IRF21/3660

Plan finalisation report – PP-2020-3305

Kellicar Road, Campbelltown Precinct

October 2021

Figure 3: Kellicar Precinct with Flood Planning Area and PMF overlaid.

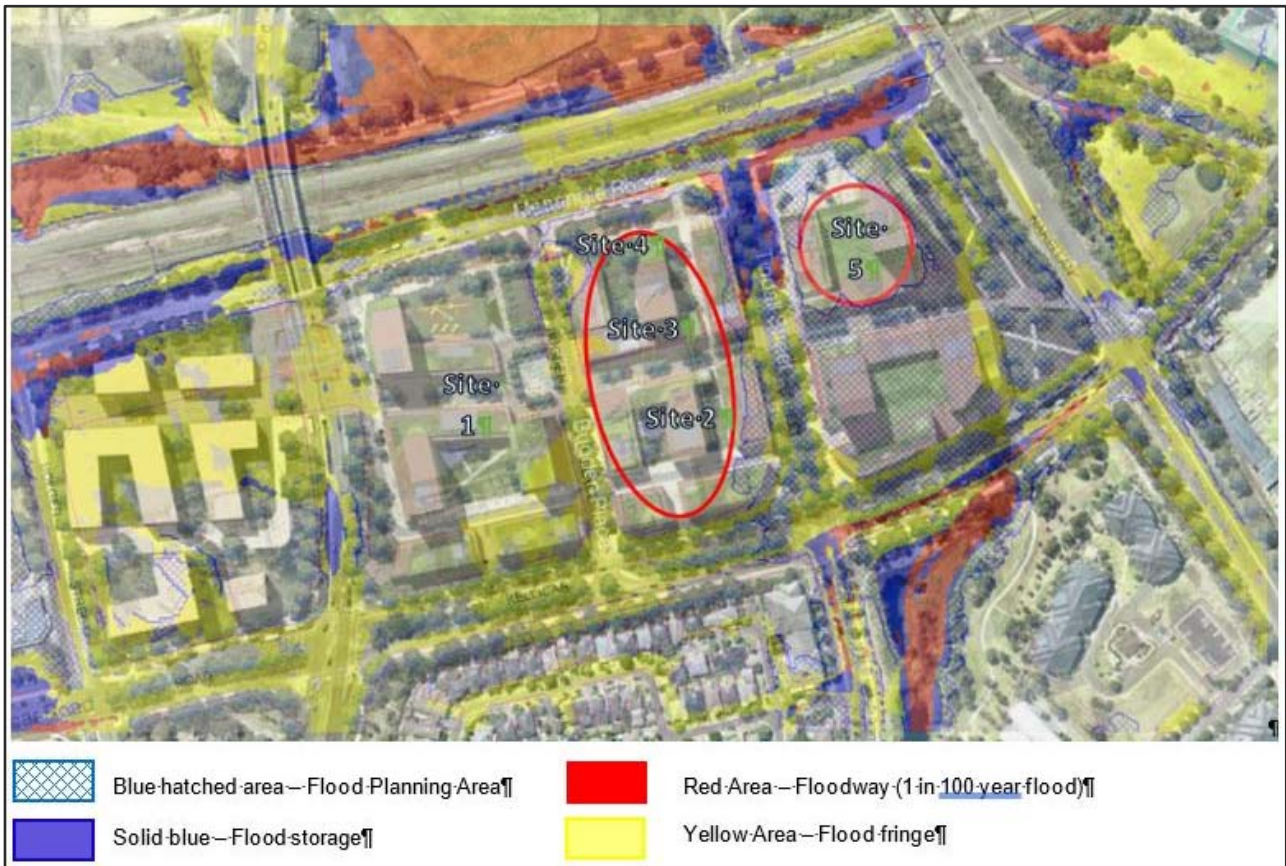
Four of the five lots within the precinct are affected by flooding with varying levels of risk. The precinct is adjacent to Birunji Creek to the south which extends across the site between Tindall Street and Narellan Road within a 10m wide drainage easement and closed culvert system. Parts of Site 4 and 5 (see Error! Reference source not found.) are impacted by the Flood Planning Area (FPA).

While the proponent has provided flood studies to support its intended outcome, the report did not adequately address the required scope in relation to emergency management. It is recommended that the issues relating to flooding should be considered across the precinct allowing for a holistic approach to evacuation and landform. While there are likely modifications which might resolve these flooding concerns, they would require a significant change to the masterplan and draft DCP, and re-exhibition of the revised scheme.

Figure 6: The Department's model of the proposed massing at 80m and 32m.

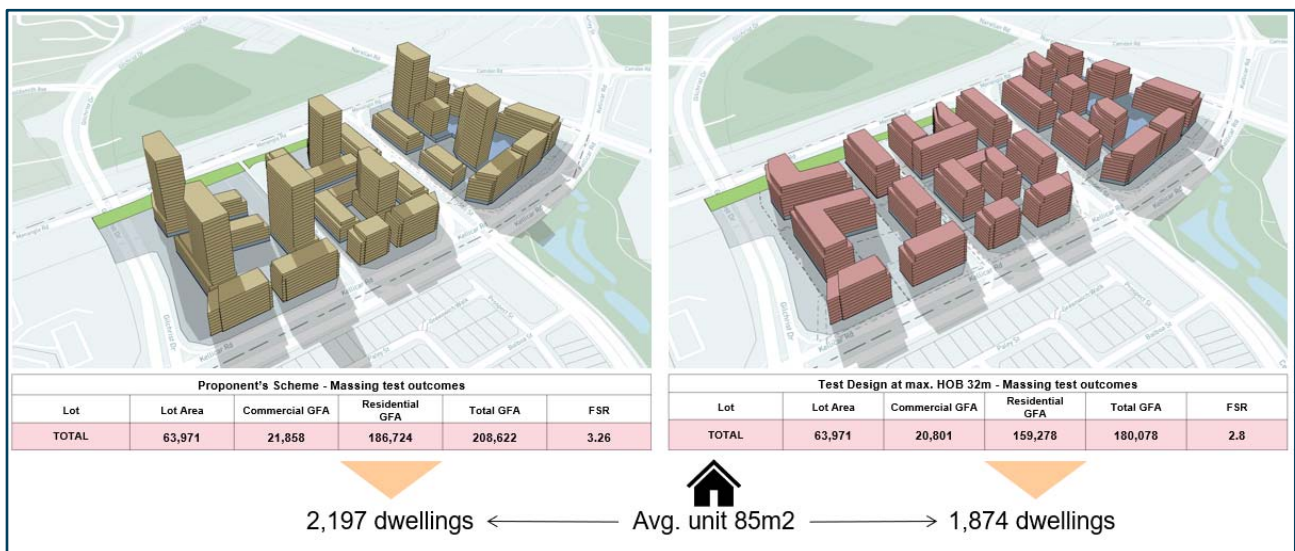
Further modelling of the precinct testing the current maximum height of 32m using the same layout and maximising building footprints to comply with the ADG building separation with all buildings at 32m, the maximum GFA failed to achieve a comparable yield (to the proposal) with approximately 180,078sqm GFA and an FSR of 2.8:1. This equates to approximately 1,874 dwellings. In reality, this yield would be significantly lower with a design which considers other factors such as overshadowing and bulk and scale. A comparison of the proposal and the testing of the current maximum height is shown in **Figure 6**.

There is no analysis within the planning proposal to support how the proposed masterplan arrived at 1,800 dwellings with a height limit of 80m and maximum FSR of 3.5:1.
